***PROPOSED ALSTONVILLE
BYPASS***

***Director-General's Report Section
115C of the Environmental
Planning and Assessment Act
1979***

February 2003

Figure 5.1 – Comparison between the EIS Design and the Revised Design for the Western Section of the Bypass

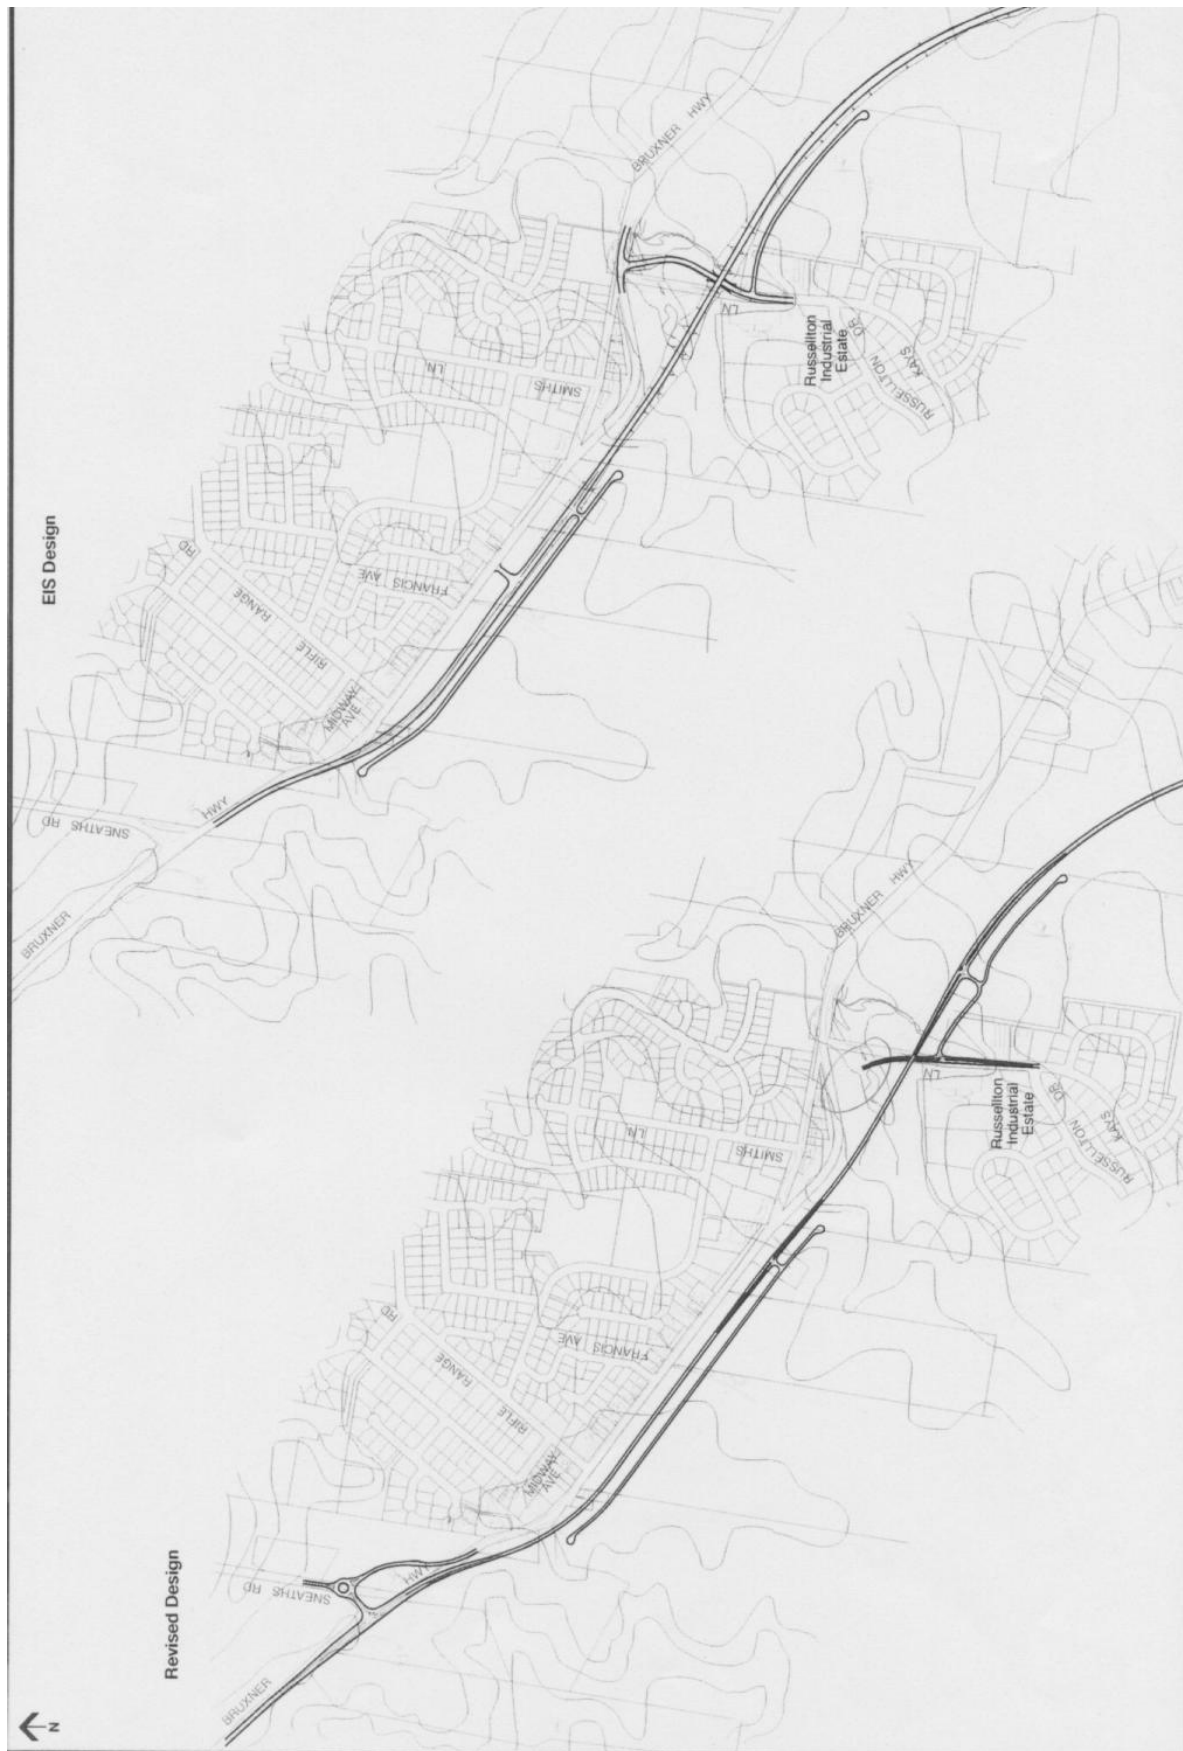
The RTA have amended the design of the western section of the proposal in response to a number of concerns raised in representations regarding the proposed location and safety of the EIS access on the bypass near Rifle Range Road and the lack of direct access to the Russellton Industrial Estate. The revised design includes:

- Modifications to Kays Lane;
- Extension of the Proposed Bypass to Sneaths Road and a new link road between Sneaths Road and Rifle Range Road; and
- Realignment of the Proposal closer to the existing Highway.

The changes are described in further detail below and illustrated in comparison to the EIS in Figure 5.1 reproduced from the Representations Report.

Figure 5.2 – Modified Kays Lane Interchange

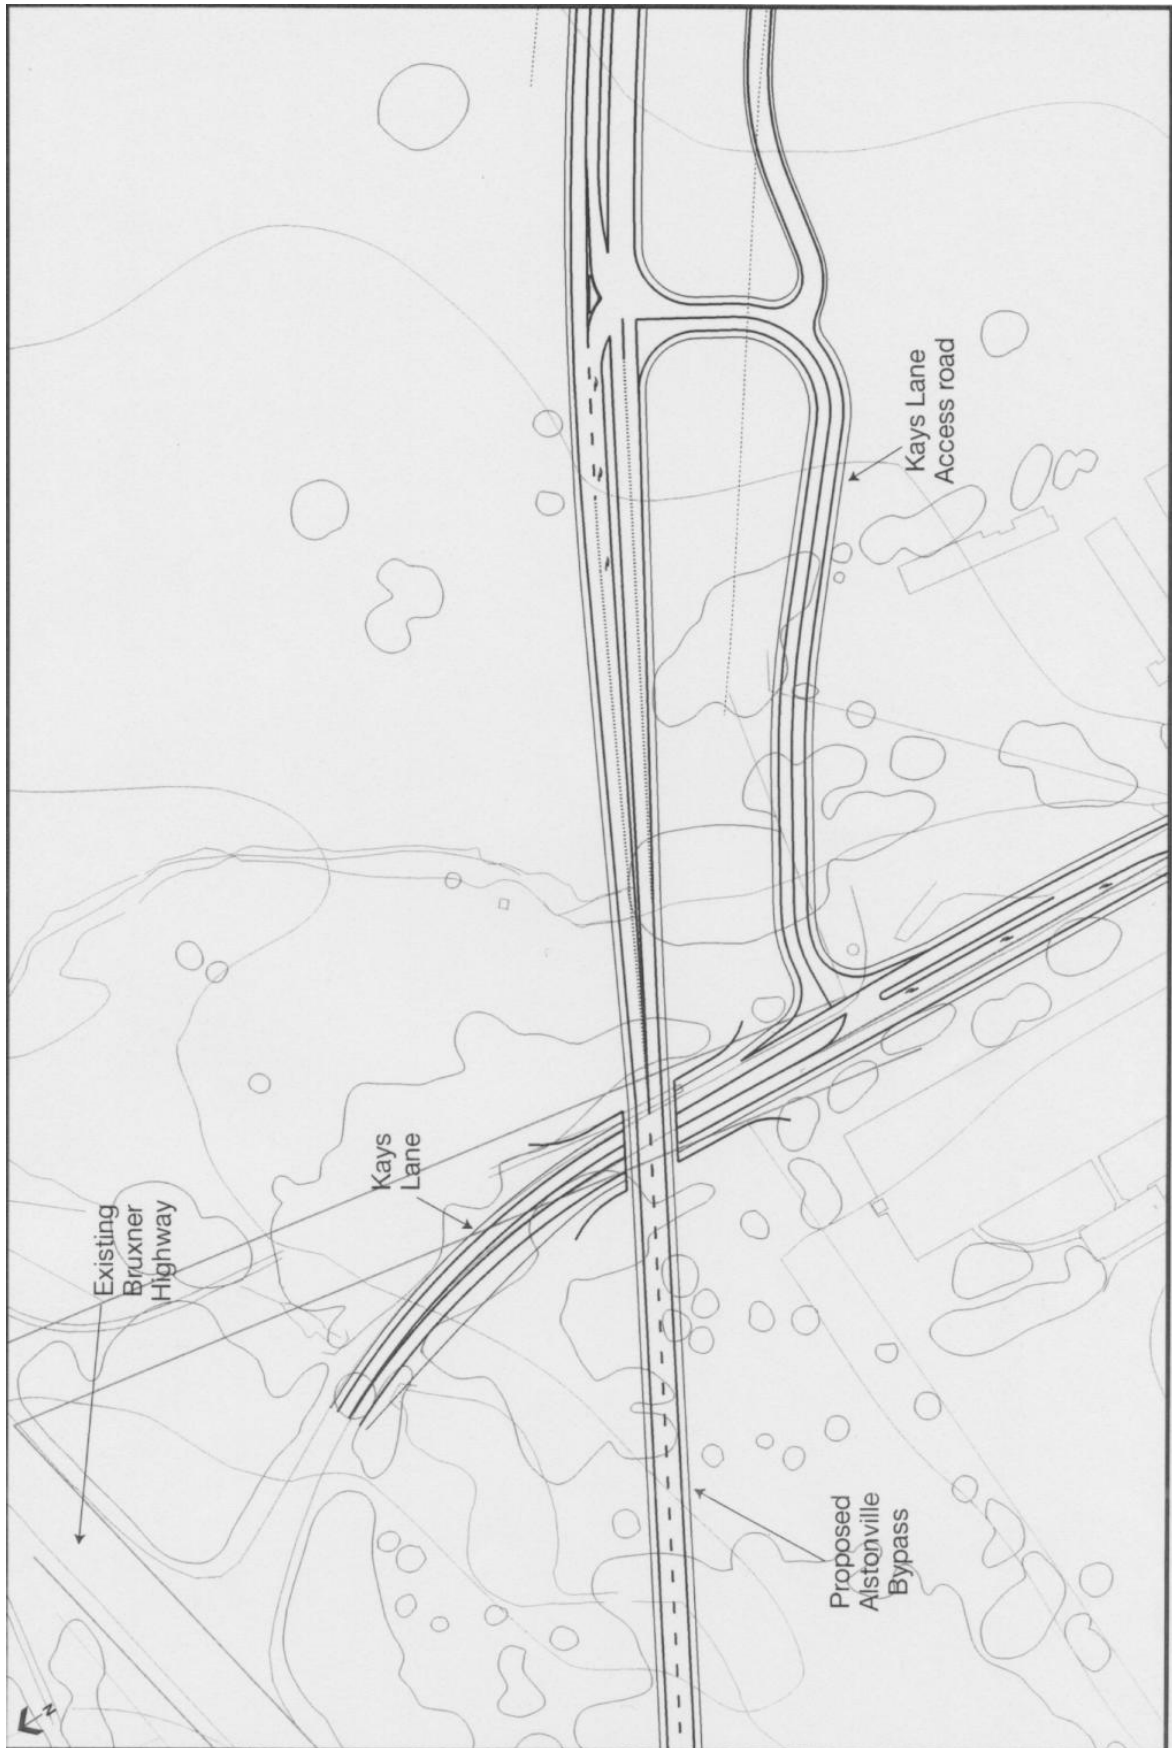
Following the review of representations the RTA considered a number of alternative interchange designs for providing direct access between the bypass and Kays Lane (Russellton Industrial Estate). The preferred option is for the construction of a two-way access road connecting the bypass to Kays Lane running to the east of Kays Lane and intersecting at the southern end of the bypass. The modification proposed includes a 'seagull' type intersection at the bypass enabling all movements and an AUSTRROADS Type C junction at the access road and Kays Lane intersection.

The proposed changes are illustrated in Figure 5.2 reproduced from the Representations Report.

Figure 5.4 – Modified Detention Basin South of Mellis Circuit

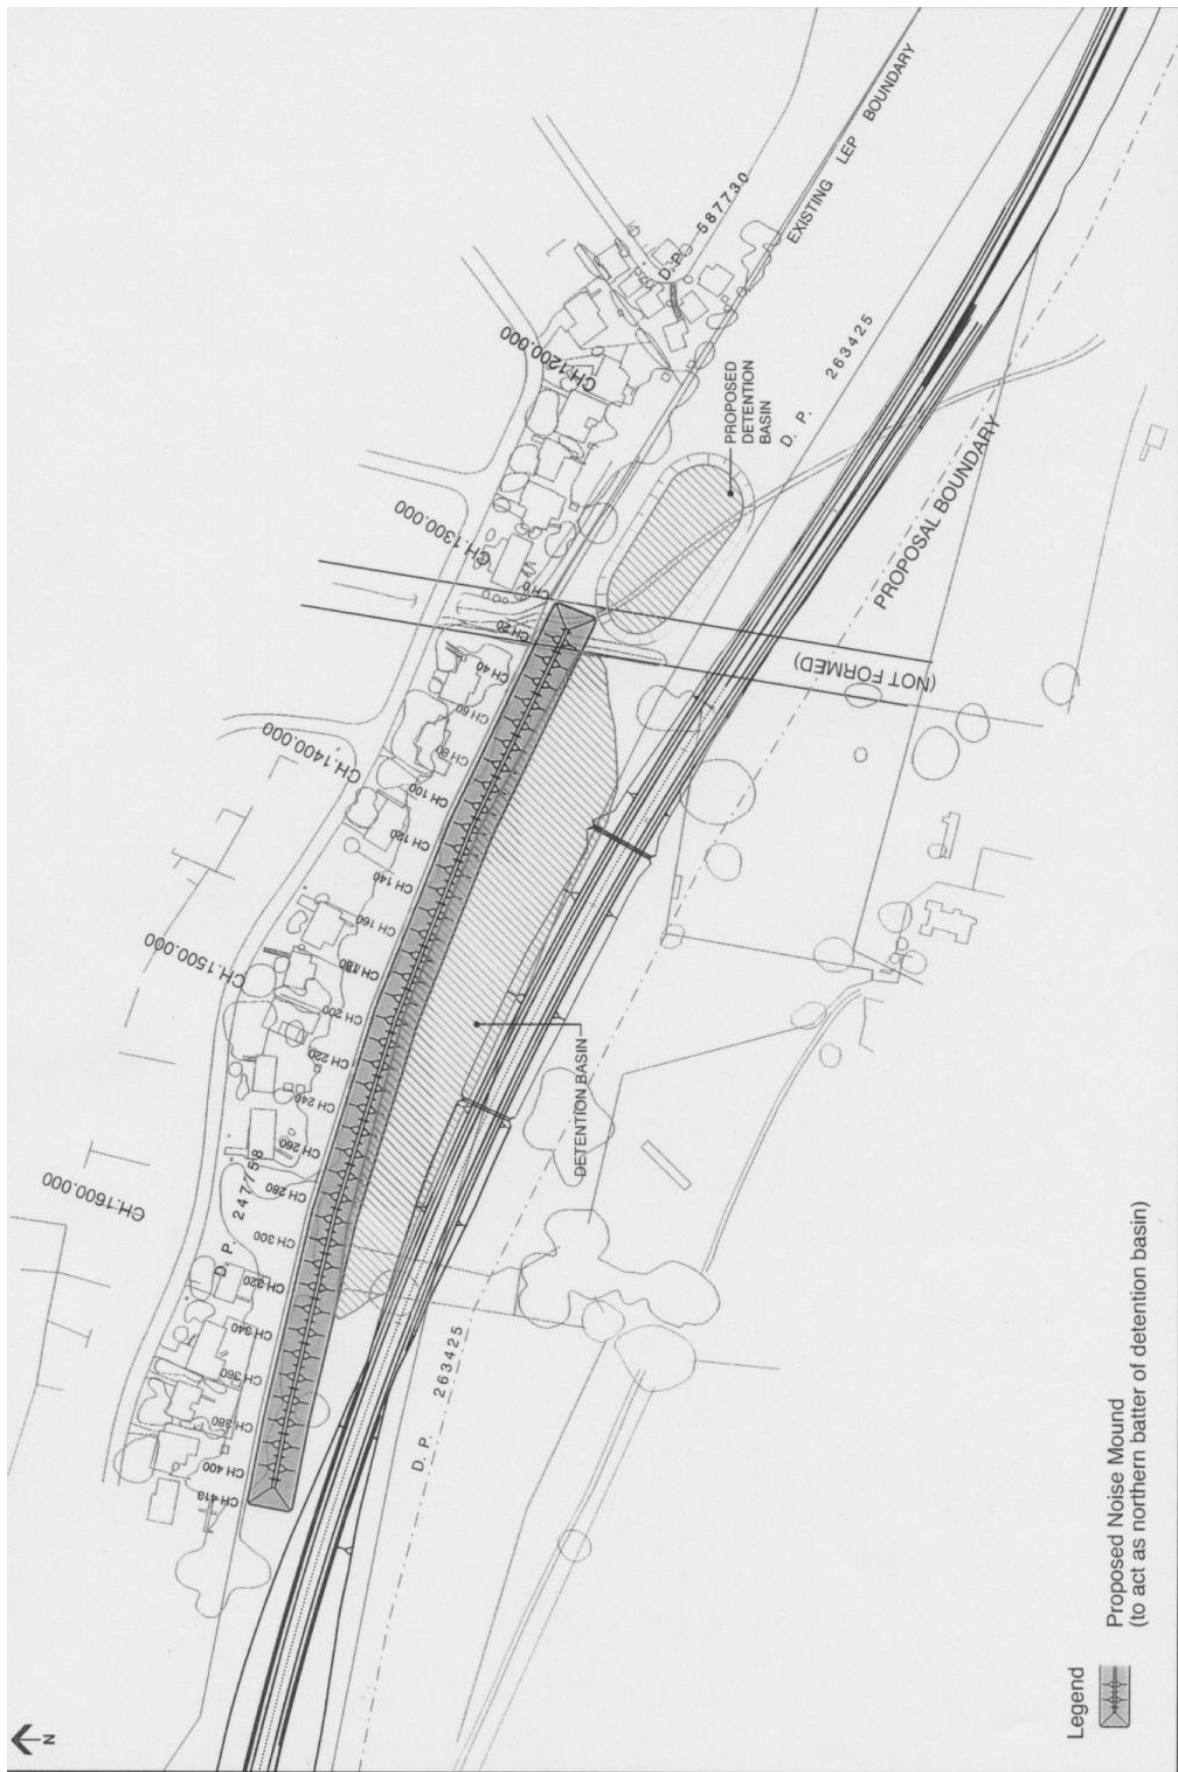
The location and scale of the detention basin at full capacity is shown in Figure 5.4 reproduced from the Representation Report.

To address the concerns of Mellis Circuit residents the RTA have modified the proposal to increase the size of the nearby stormwater detention basin from 4,500m³ in the EIS to 11,770m³. The RTA stated that locating the two detention basins to the south of the proposal was not preferred due to impacts upon agricultural land. The RTA also stated that they would discuss measures with BSC to ensure that their measures were incorporated into any BSC plans.
